## SERVICE BULLETIN AMATEUR RADIO

SUBJECT TS-440S OPERATION WITH THE MC-85	DATE 01/20/89
---	------------------

FIGURE 1

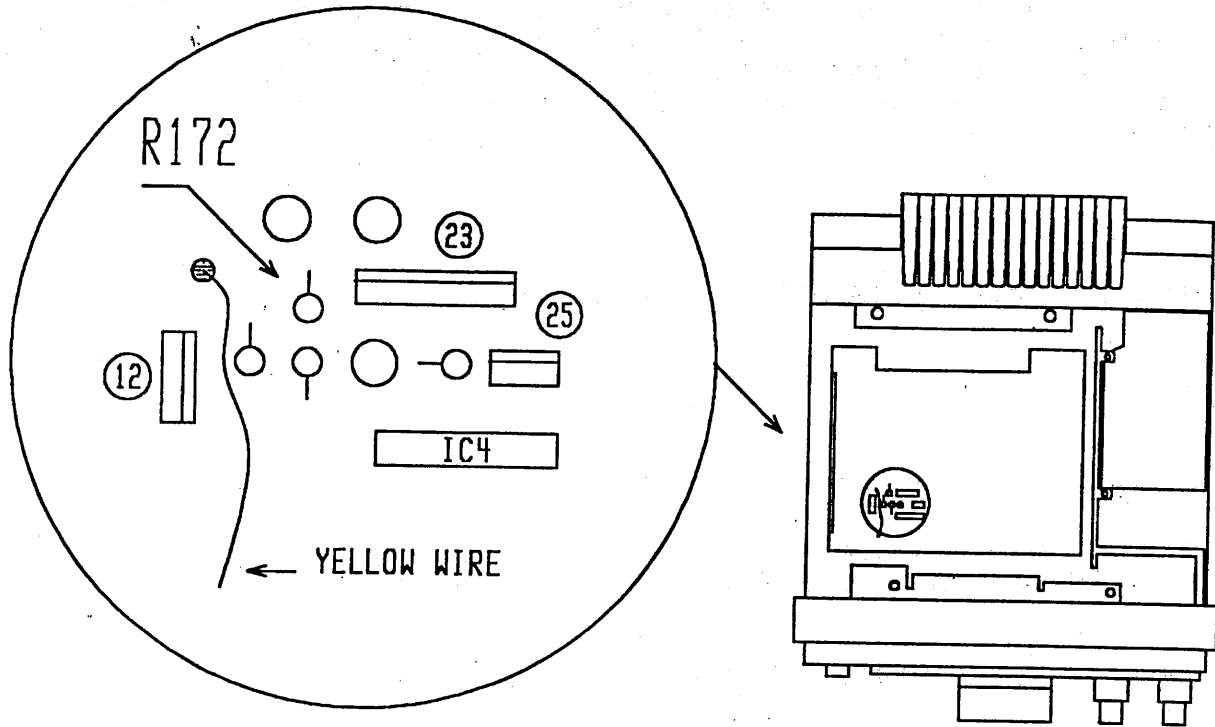
With some TS-440S transceivers, insufficient modulation may occur when the MC-85 compression switch is turned on. This may be caused by too much of a voltage drop across resistor R172 on the IF unit of the transceiver. If this is found to be the case, change the resistor from 1K ohm to 100 ohms.

1. Disconnect the power supply and antenna from the transceiver.
2. Using a #2 Phillips screw driver, remove the 9 screws from the top cover of the transceiver. Remove the cover and unplug the speaker wire.
3. Locate resistor R172 on the component side of the IF board (Figure 1).
4. Using a #1 Phillips screw driver, remove the 7 screws that secure the IF unit to the chassis of the transceiver.
5. Pull the board up and rotate it towards the front of the transceiver to expose the foil side of the board.
6. Desolder and remove resistor R172 from the board.
7. Install and solder the 100 ohm resistor in place of R172.
8. Assemble the transceiver by reversing steps 1 - 5.
